Stanwell Corporation Limited (Stanwell) welcomes the opportunity to comment on the Optional Firm Access Supplementary Report: Pricing as published by the AEMC on 31 October 2014.

OPTIONAL FIRM ACCESS  
RESPONSE TO AEMC SUPPLEMENTARY  
PRICING REPORT

DECEMBER 2014

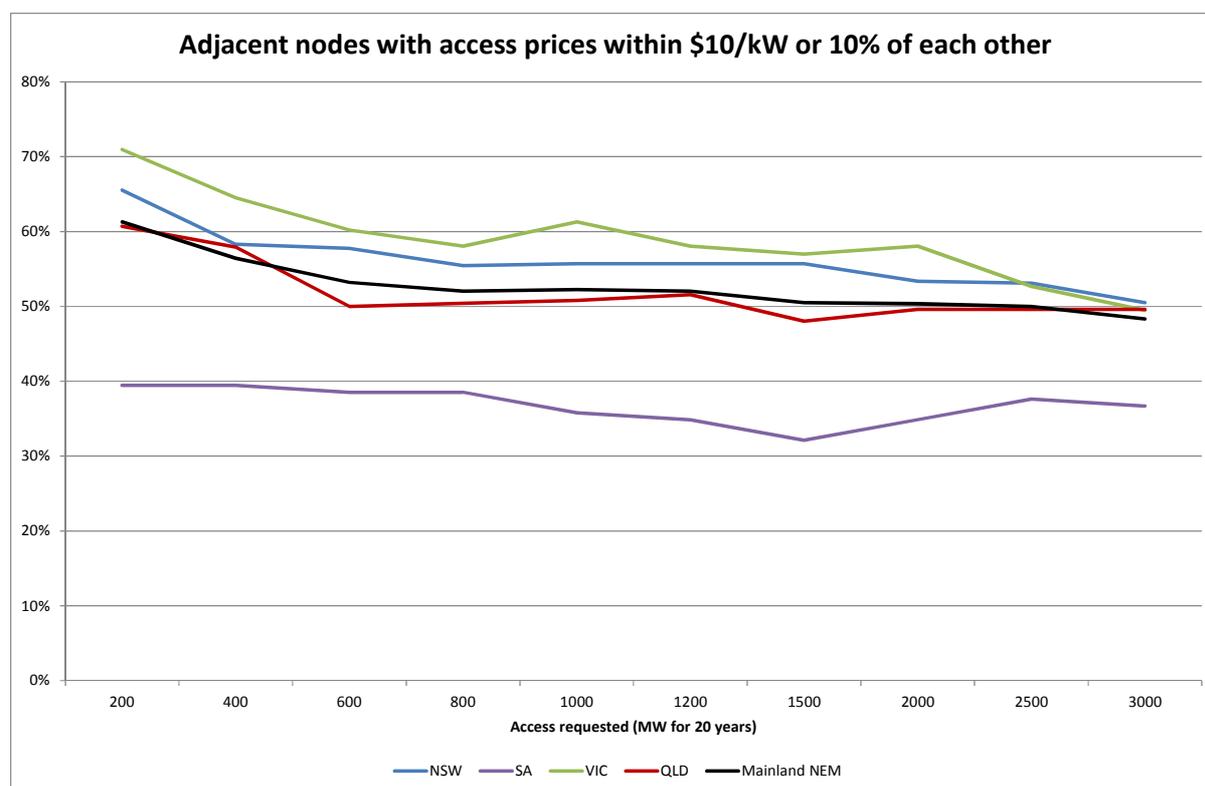
As shown below, access pricing shows a strong correlation with nearby locations. For example over 60% of neighbouring mainland locations have access prices within 10% or \$10/kW<sup>4</sup> of each other for a 200MW access request. While the proportion drops slightly as request size increases it remains above 50% across the bulk of foreseeable requests.

This analysis confirms that the locational signal provided by the prototype is generally quite weak.

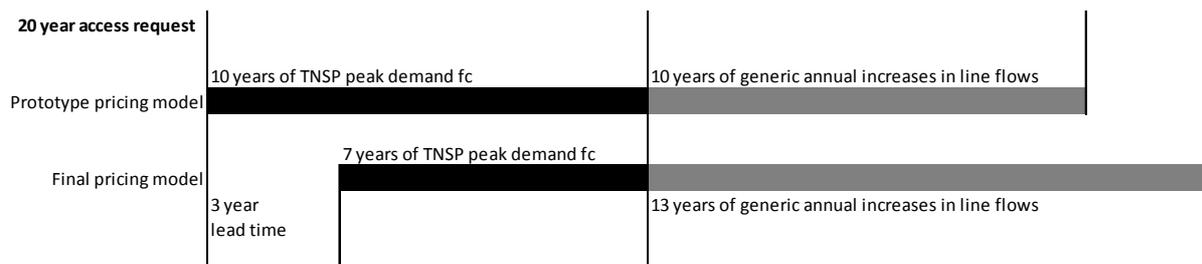
The implication of the minimum transmission lead time is that the forecasts underpinning the pricing model will be less reliable. For example for a 20 year access request, a 3 year lead time means 13 years of the request are priced using less reliable generic line growth assumptions. This is illustrated in the diagram below.
